# City of Portland Design Commission

## Design Advice Request

**EA 22-125279 DAR – New 7-story apartment building including ground floor retail  
Design Advice Request Memo – May 19, 2022**

### 6. Courtyard and Outdoor areas:

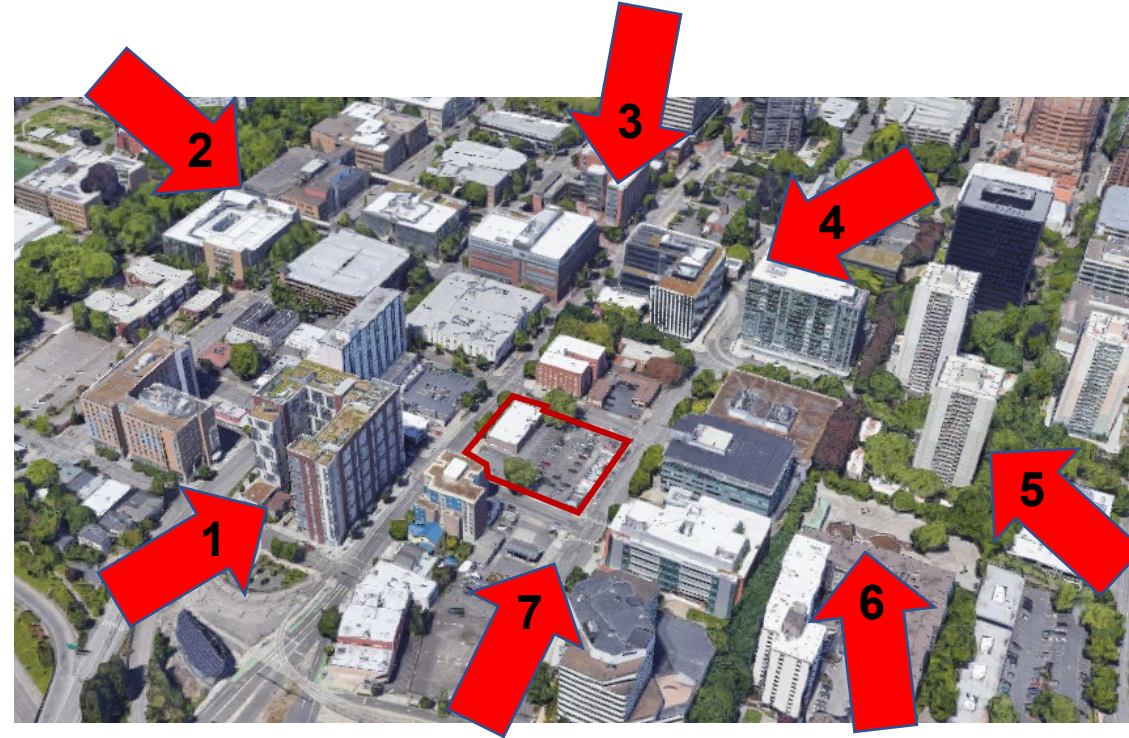
- Current programming includes residential dwelling units at the ground floor, which are prohibited.
  - *As mentioned, the courtyard cannot include residential dwelling units. The required change in program at the courtyard is an opportunity to successfully meet these guidelines at SW College.*
  - *Staff, again, raises the lack of a contextual response to the adjacent campus and pedestrian-rich Halprin Sequence. These adjacencies offer ample pedestrian spaces, as should the proposal.*

### 3. Balconies:

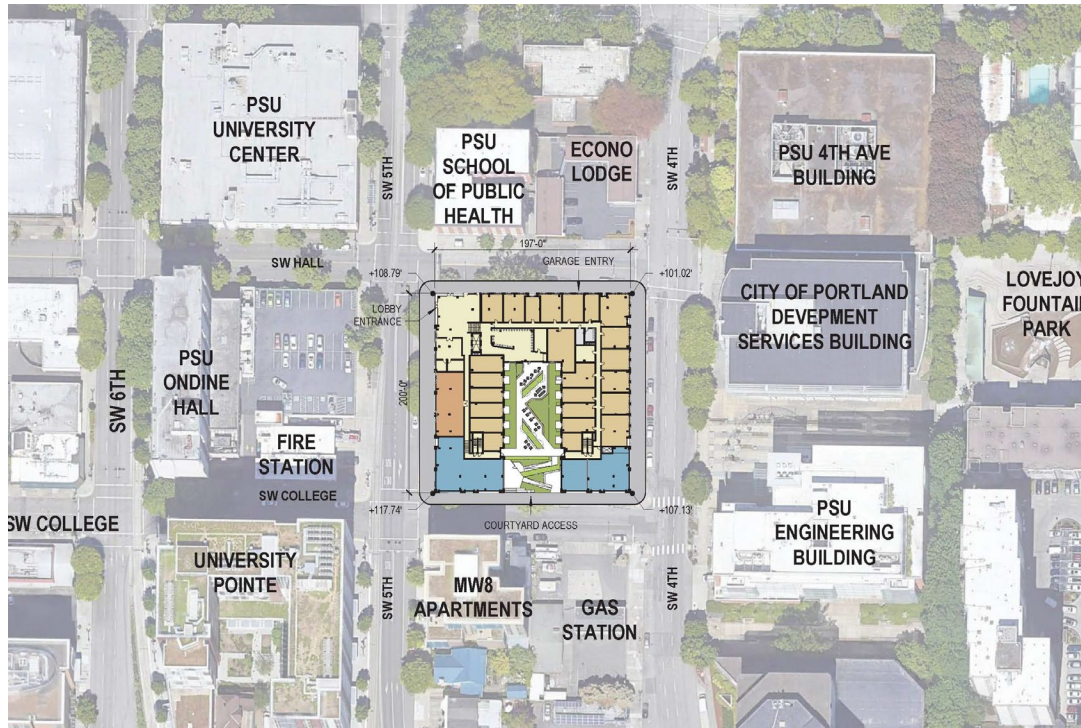
- 250 units are proposed however only 43 balconies are shown - approximately 17% of the units have balconies.
  - *Staff is concerned with the lack of balconies primarily as outdoor amenities to the residents, but also as architectural features helping to break down the mass of the building on all frontages.*

**5. Building Frontages and activation:**

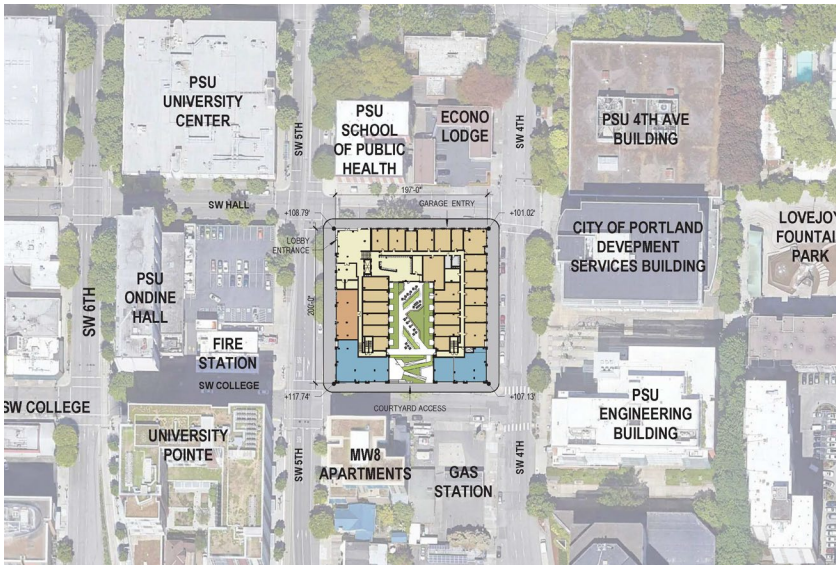
- The full block building activates SW 4<sup>th</sup> and SW 5<sup>th</sup> with retail, however, 1/3 of SW College is inactive due to the proposed courtyard area at the street frontage, and the majority of SW Hall is inactive and treated as back-of-house.
  - *Staff requests comments on the proposed activation of the ground floor at the street frontages on all elevations.*
  - *For a site that sits between a campus and the pedestrian-rich Halprin Sequence, staff requests comments on whether additional amenities should be provided on all frontages at the ground level to make places for people to pause, rest, and comfortably inhabit the spaces.*
